March 1, 2019

**CN Milton Logistics Hub (“Project”)
CEAR File No. 80100**

**CN Response to the Review Panel’s Information Request 8
Received September 25, 2018**

Figure IR8.4-1 Recommended Practice for Bicycle Lane Adjacent to Introduced Right-Turn Lane

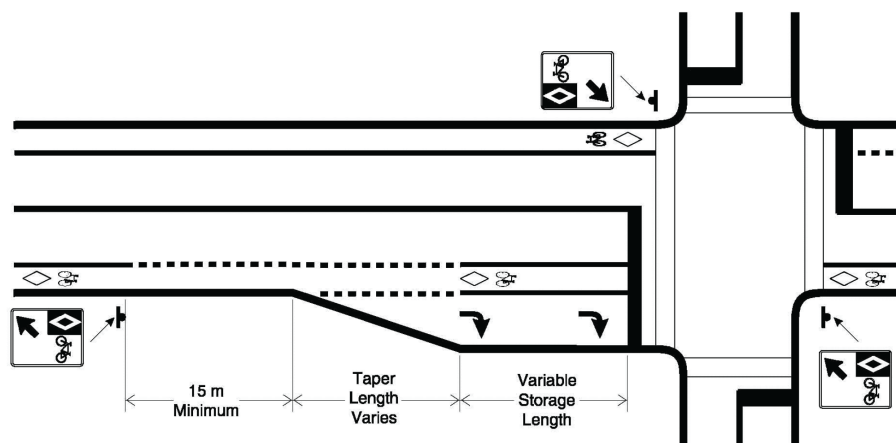
- c) Explain why the intersection designs shown Figure 4 of Attachment IR2.33-2 of CN's response to information request #2.33 with Figure 7 of Attachment IR2.33-1 are different and indicate which one of the intersection designs is the one being proposed. In the response, indicate how the intersection design will accommodate cyclist traffic.

c) *Explain why the intersection designs shown Figure 4 of Attachment IR2.33-2 of CN's response to information request #2.33 with Figure 7 of Attachment IR2.33-1 are different and indicate which one of the intersection designs is the one being proposed. In the response, indicate how the intersection design will accommodate cyclist traffic.*

reducing the potential impact on through lane operations. In the proposed design (contained in Figure 7 of Attachment IR2.33-1 (CEAR #592)), eastbound right-turning vehicles cross the bicycle lane upstream of the intersection, removing the conflict zone from the intersection and creating a longer transition area for vehicles to cross the bicycle lane into the right turn lane further upstream. This configuration is the recommended practice in current design standards used in Ontario and elsewhere including the Transportation Association of Canada (TAC) "Geometric Design Guide for Canadian Roads Chapter 5 – Bicycle Integrated Design" (June 2017), the Ontario Traffic Manual (OTM) "Book 18 – Cycling Facilities" (December 2013), and the National Association of City Transportation Officials (NACTO) "Urban Bikeway Design Guide" (March 2014). The recommended practice contained in the Ontario Traffic Manual (OTM), which is also the source of the diagram shown in Figure 4 of Attachment IR2.33-2 (CEAR #592), is illustrated in **Figure IR8.4-1** below.

True North Safety Group concurs, and has confirmed, that the proposed design for the Britannia Road / Terminal Access Road intersection (contained in Figure 7 of Attachment IR2.33-1 (CEAR #592)) appropriately accommodates bicycles on Britannia Road, is in line with current design standards, and does not change the conclusions of the safety assessment contained in Attachment IR2.33-2 "Safety Assessment of Site Accesses at the Proposed CN Logistics Hub" dated April 5, 2017 (CEAR #592).

In comparison to the above diagram, Figure 4 of Attachment IR2.33-2 (CEAR #592) ("Bicycle Lane Adjacent to Combined Through/Right Turn Lane (Solid Line With Optional Staggered Stop Bars; OTM Book 18, 2013)") is a conceptual diagram illustrating a road configuration *without* a dedicated right turn lane, but rather with a shared through-right turn lane and curbside bicycle lanes. That diagram was reproduced from Figure 4.41 of the Ontario Traffic Manual (OTM) Book 18 and was provided as a recommendation in the event that a shared through-right lane is provided in the eastbound direction.
